Project: MU/Patient Care Tower-1230- MRI Room

Subject: Addendum No. 1

ADDENDUM #1

TO CONTRACT DOCUMENTS FOR: Project #CP245321 – Patient Care Tower – T1230 MRI Room

1 Level 1 - CEILING PLAN - LIGHTING
 1/4" = 1'-0"

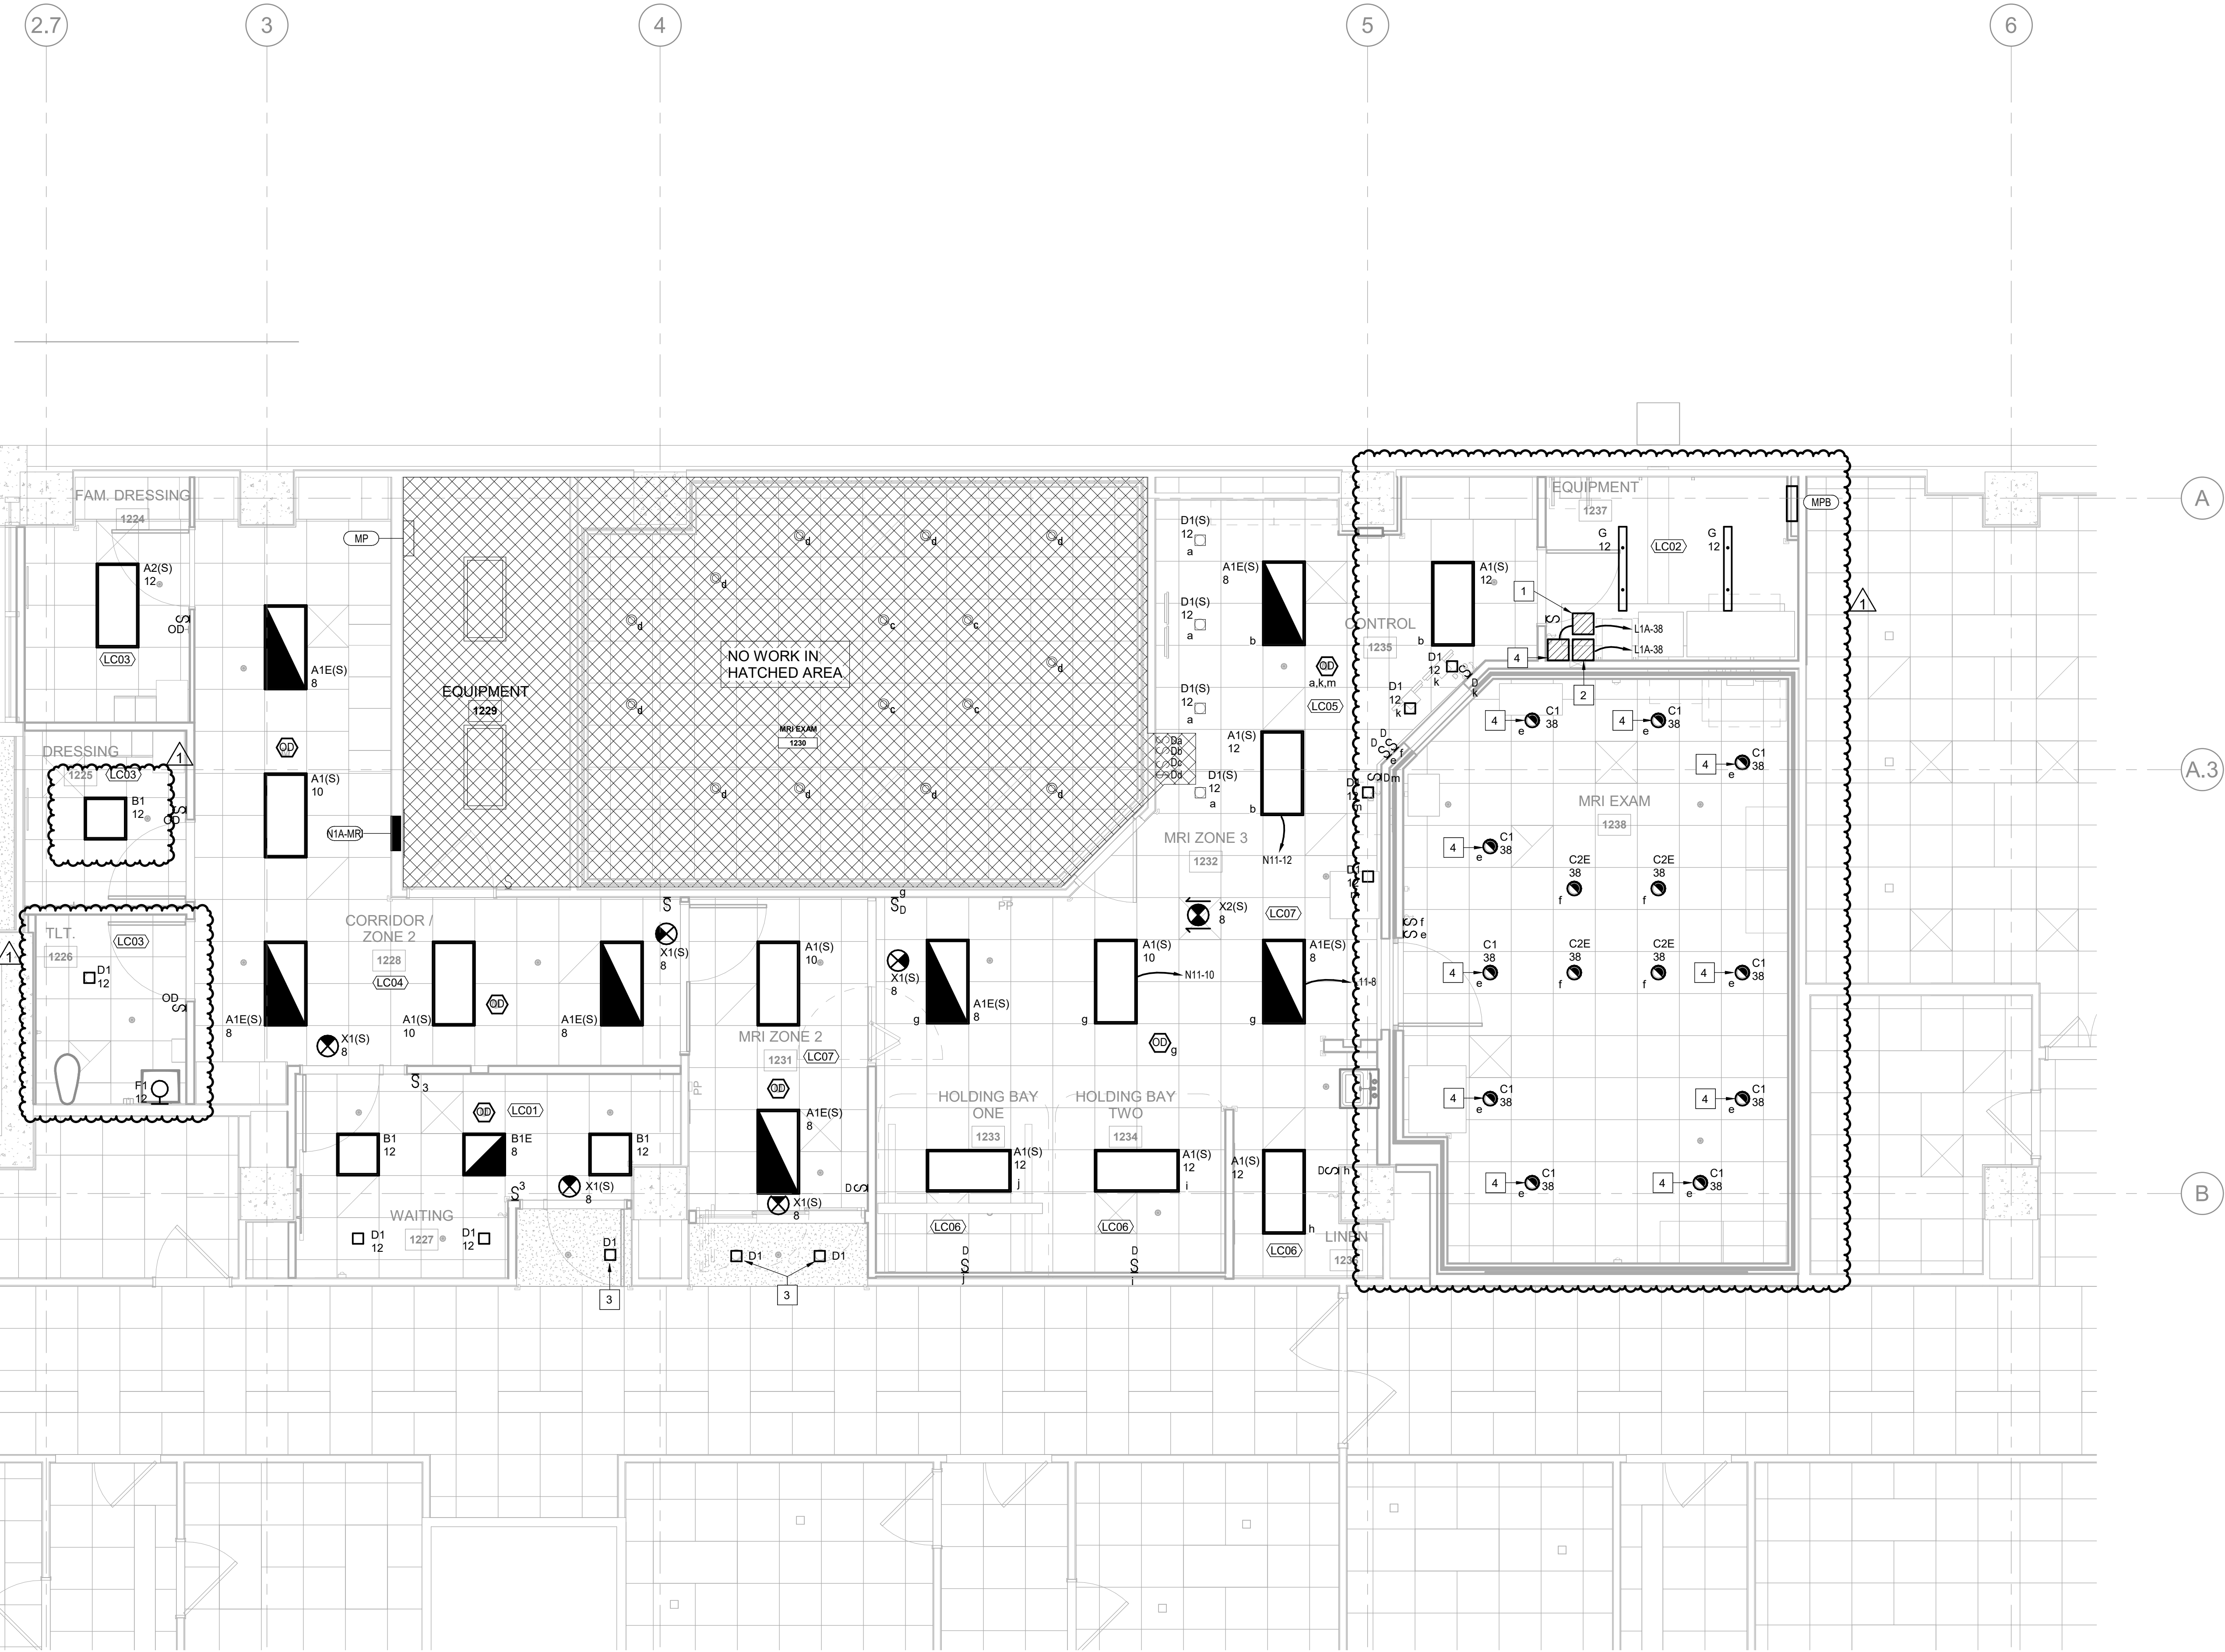
- 5) E2.2 – Lighting First Floor New Work Plan
 - a. **REVISED** plan notes 4.
 - b. **REMOVED** plan notes 5 & 6.
 - c. **REVISED** dressing 1225 B1(S) fixture to B1.

- d. **REVISED** TLT 1226 D1(S) & F1(S) fixture to D1 & F1.
 - e. **ADDED** plan notes 4 to fixtures in MRI Exam 1238.
 - f. **REVISED** A1(S) fixture in Equipment 1237 to type G.

1 Level 1 - FLOOR PLAN - POWER
 1/4" = 1'-0"

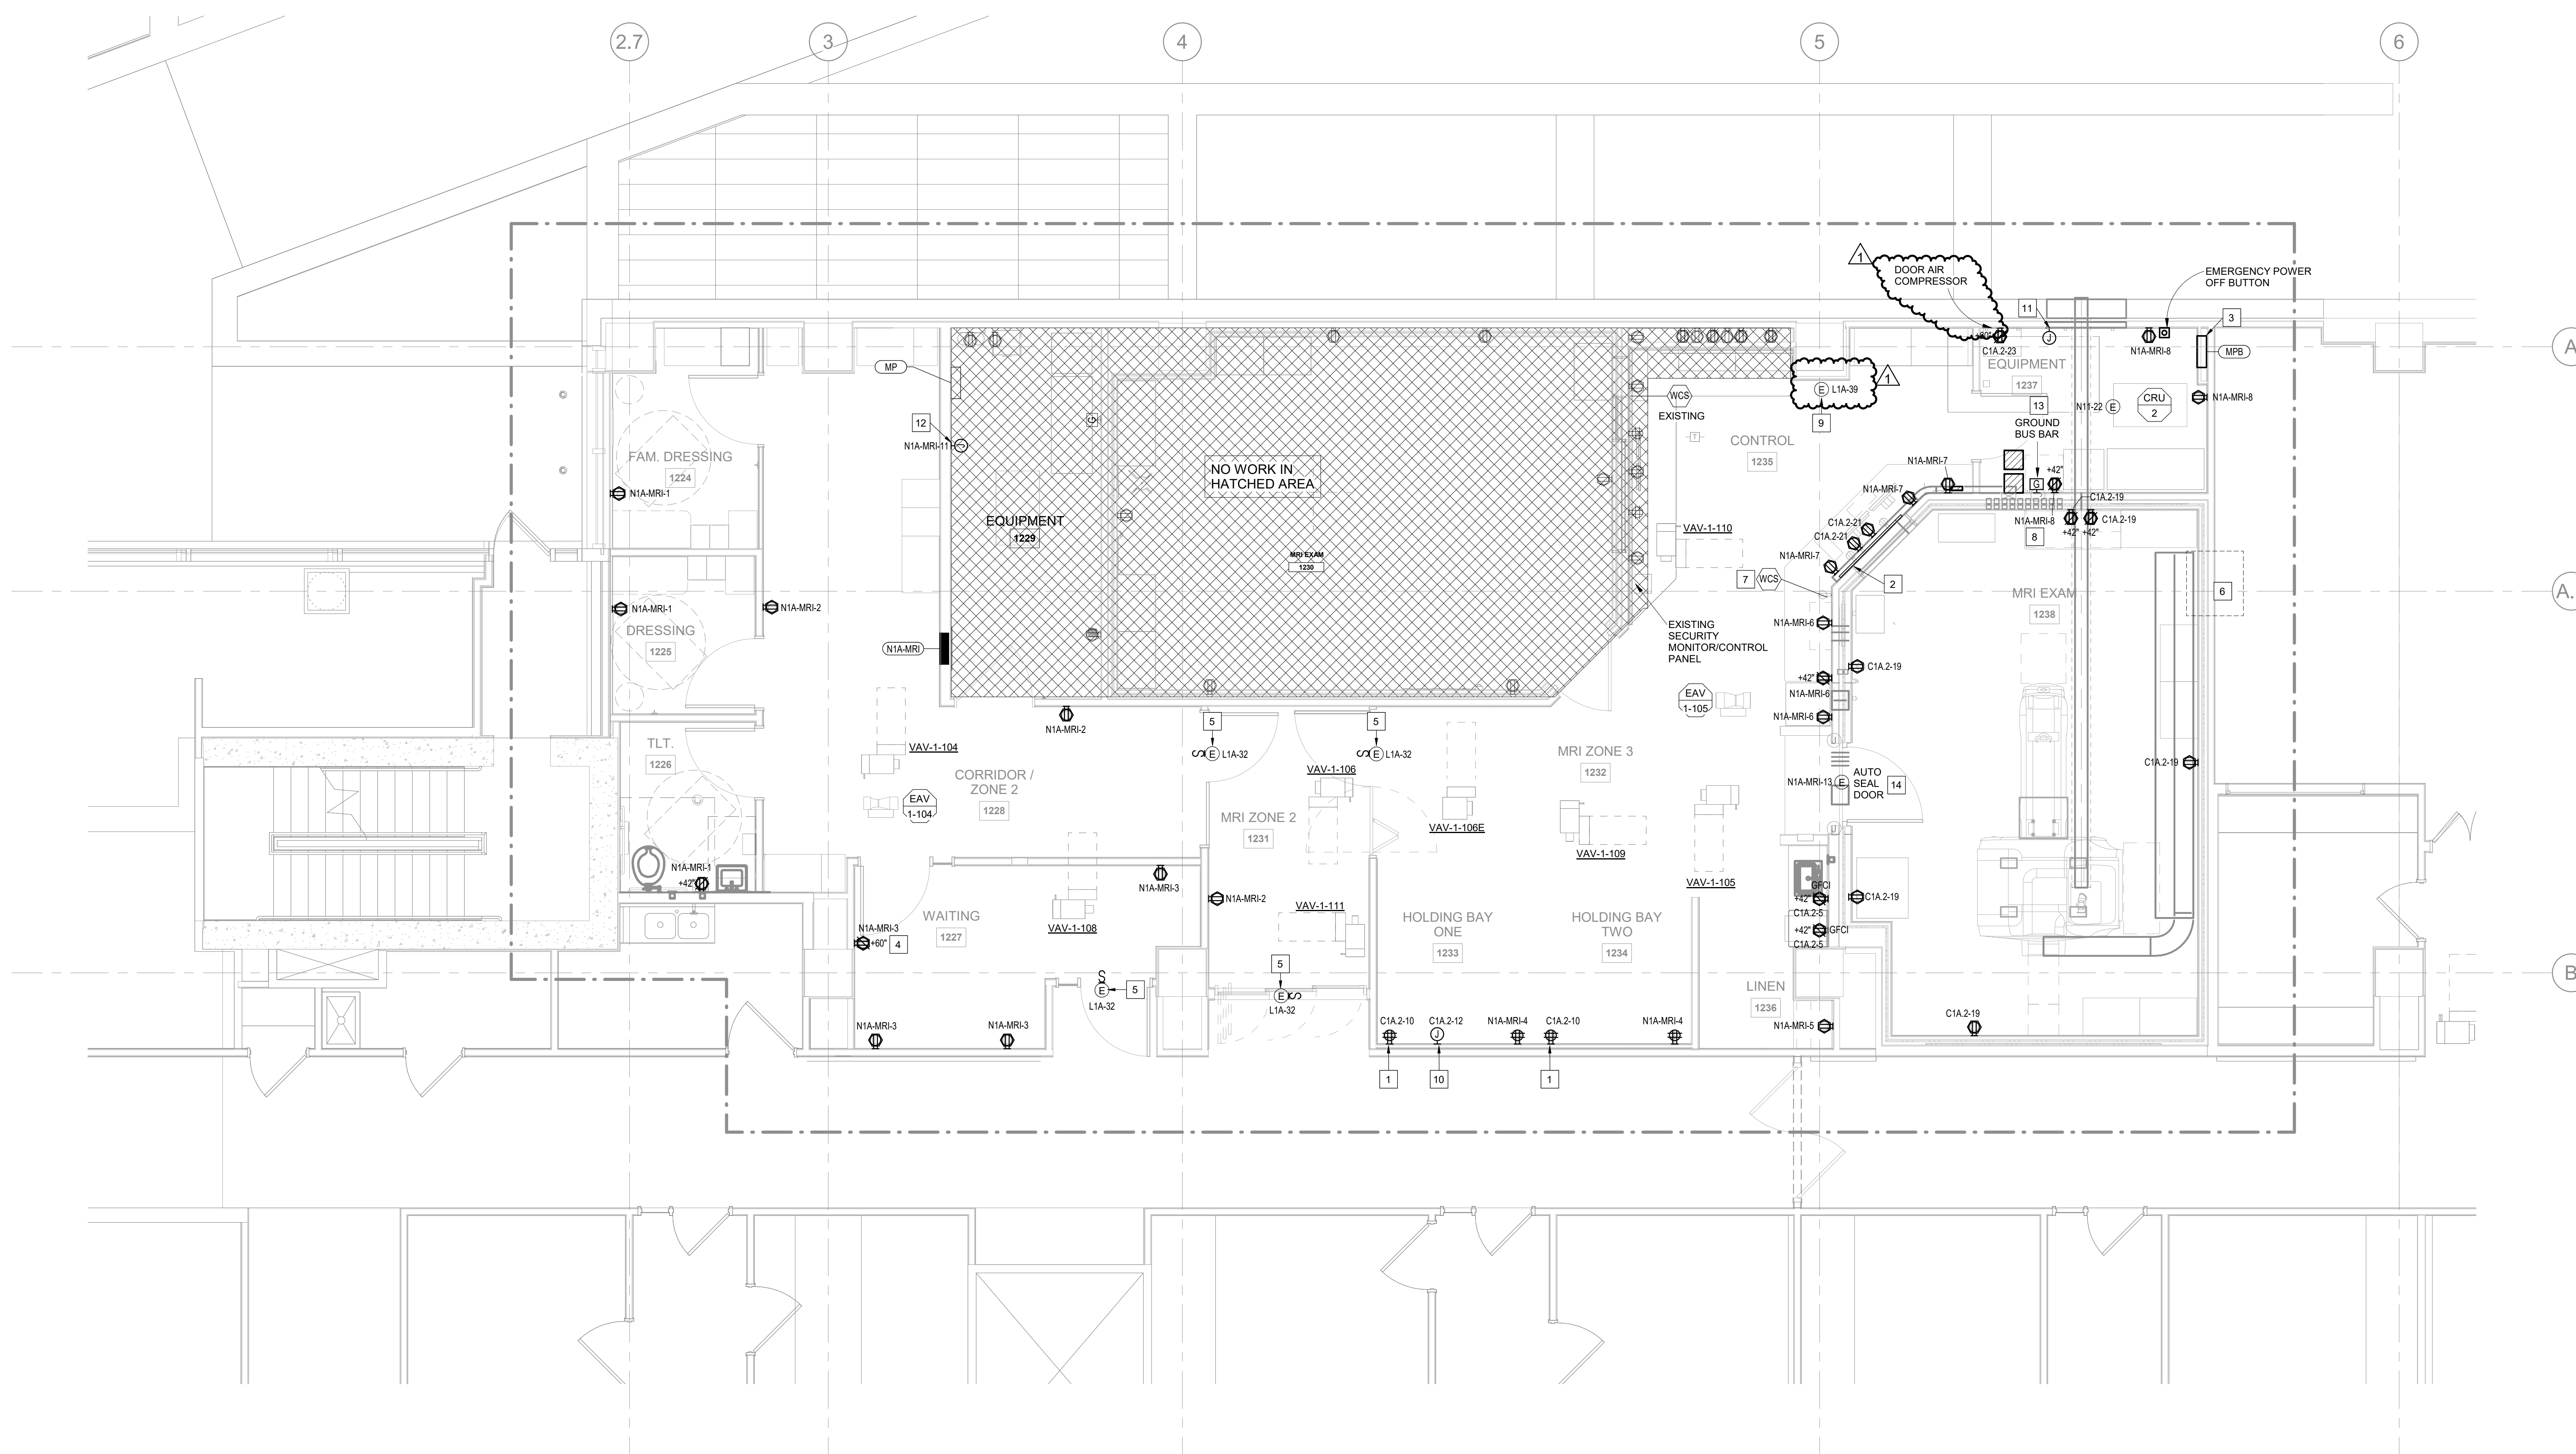
- 6) E2.3 – Power First Floor New Work Plan
 - a. **REVISED** plan notes 6 & 11.
 - b. **ADDED** annotation to clarify the Door Air Compressor outlet.
 - c. **REVISED** med alarm circuit from N1A-10 to L1A-39 in Control Room 1235.

1 ROOF - FLOOR PLAN - POWER
 1/4" = 1'-0"

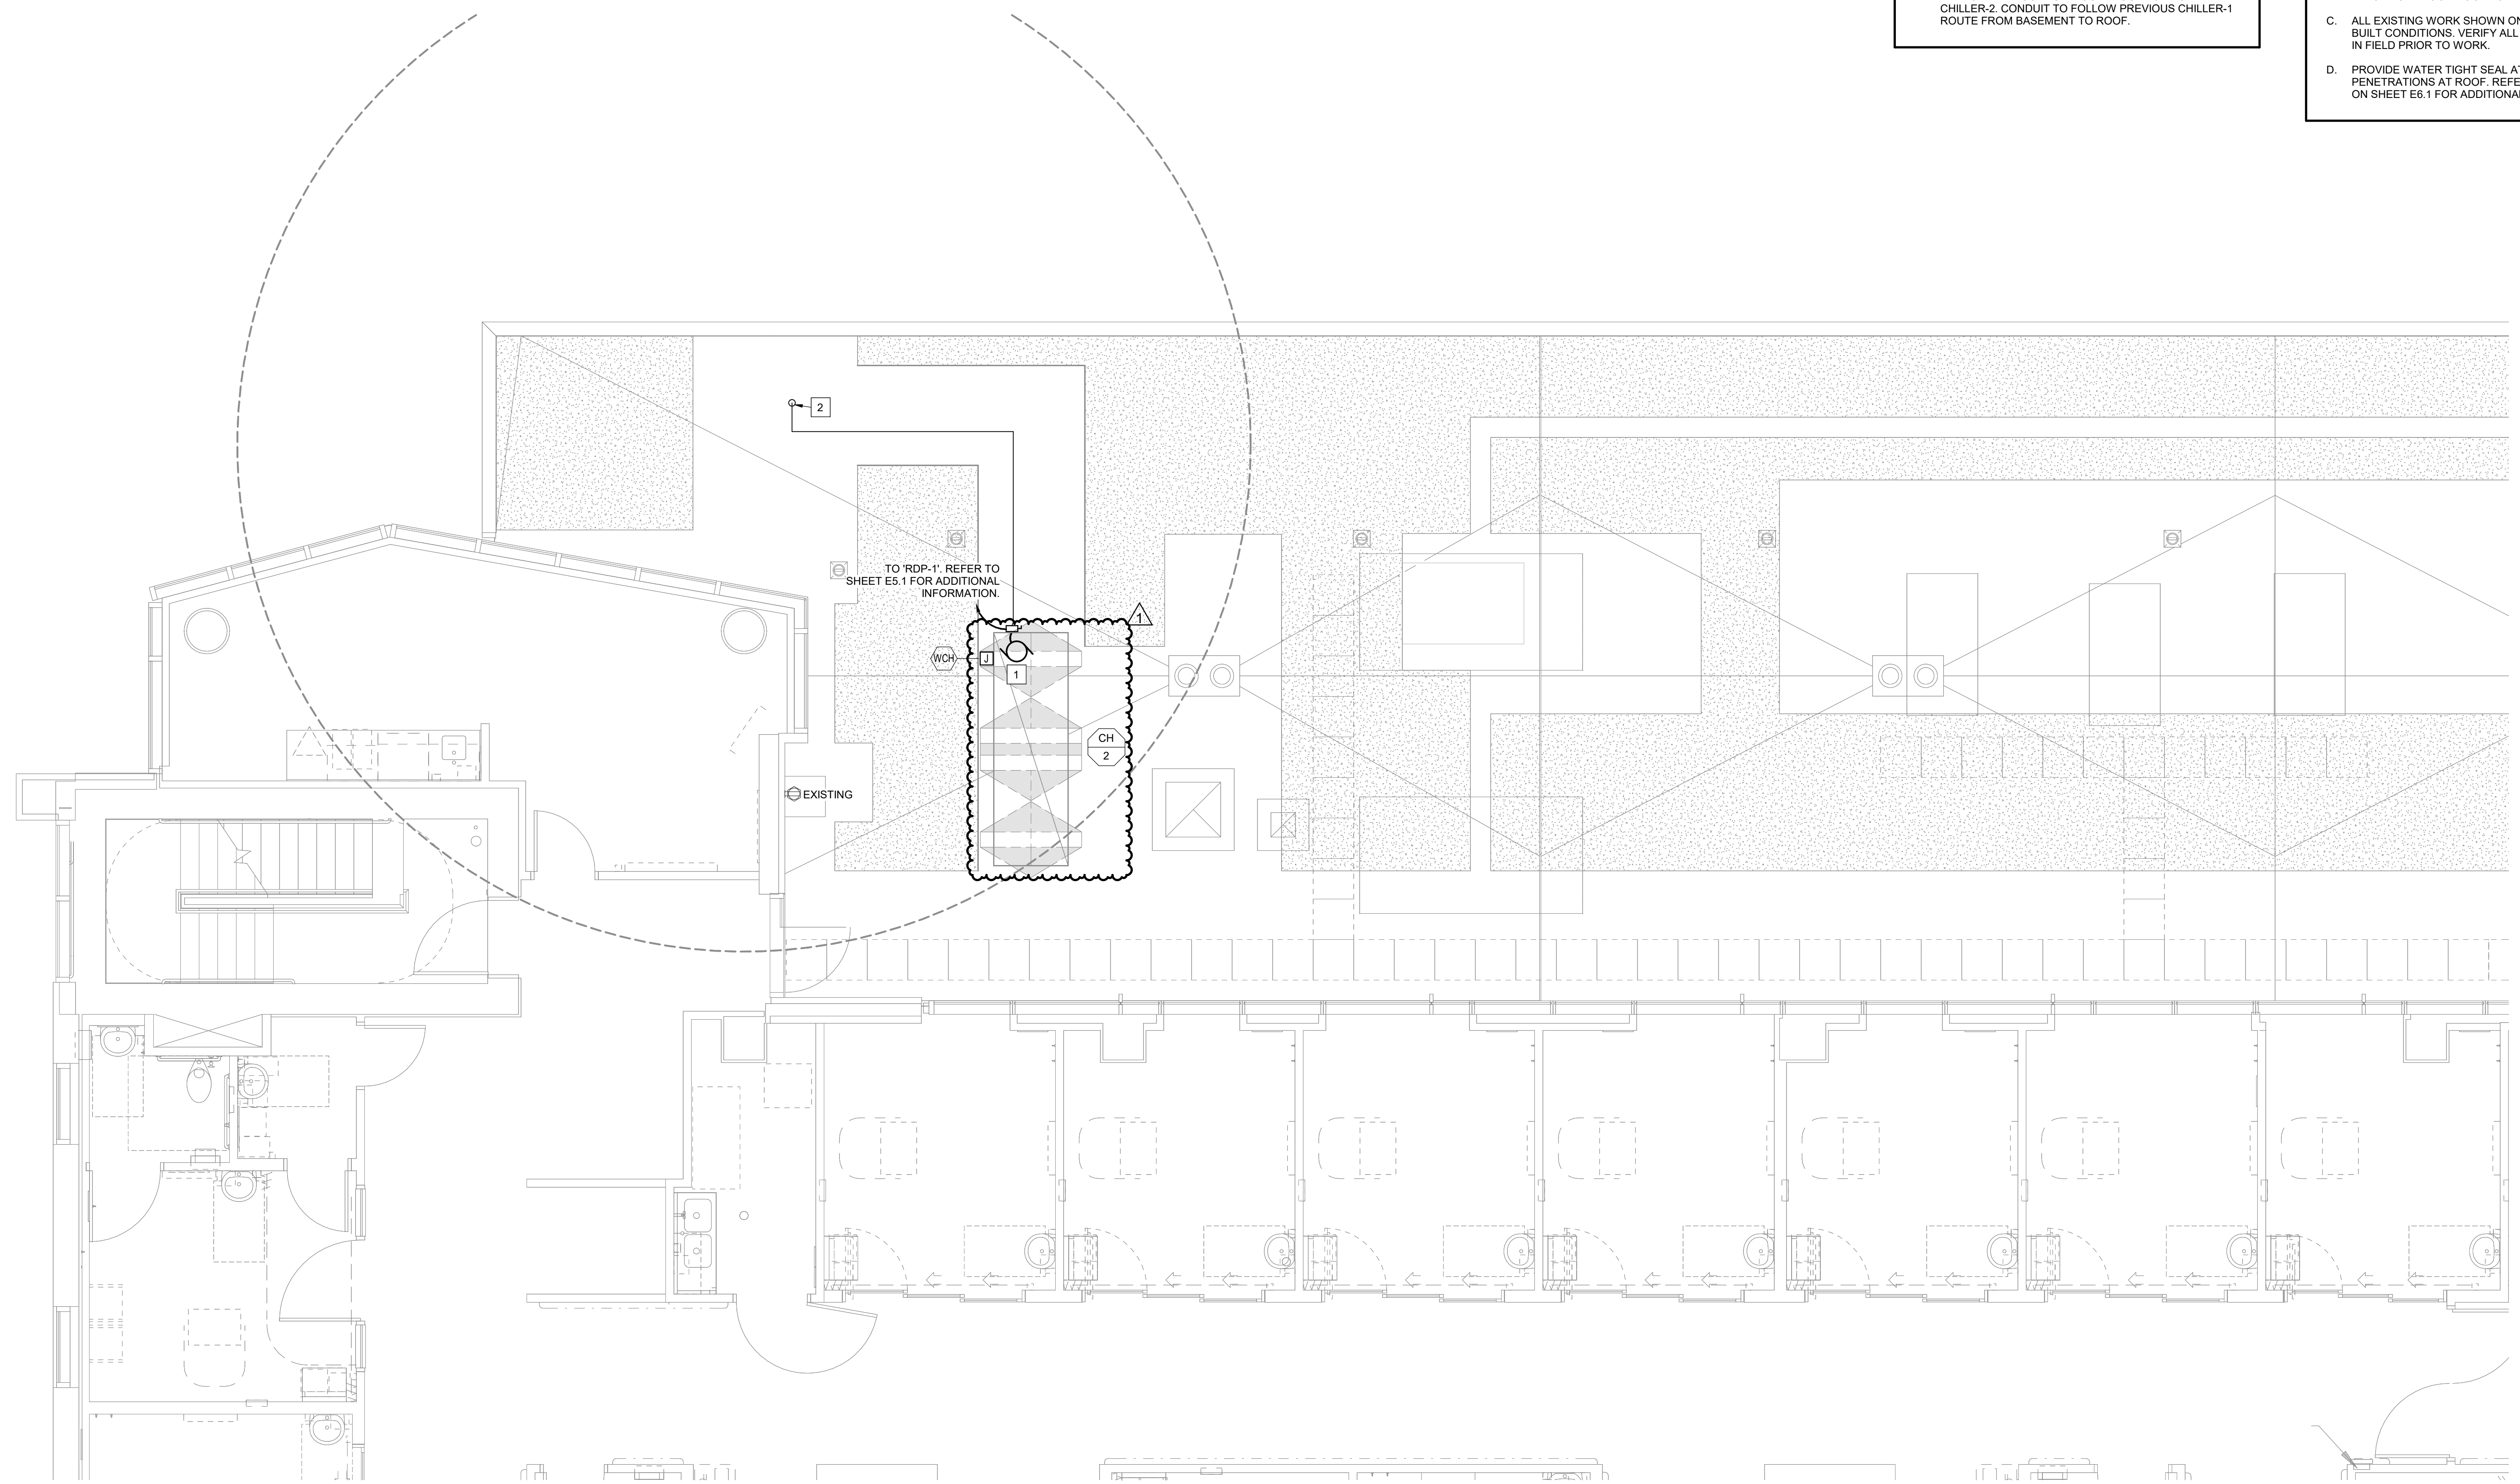
- 7) E2.4 – Power Roof Plan
 - a. **REVISED** disconnect location based on updated background and mechanical equipment size.
- 8) E2.5 – Siemens Equipment Plan New Work
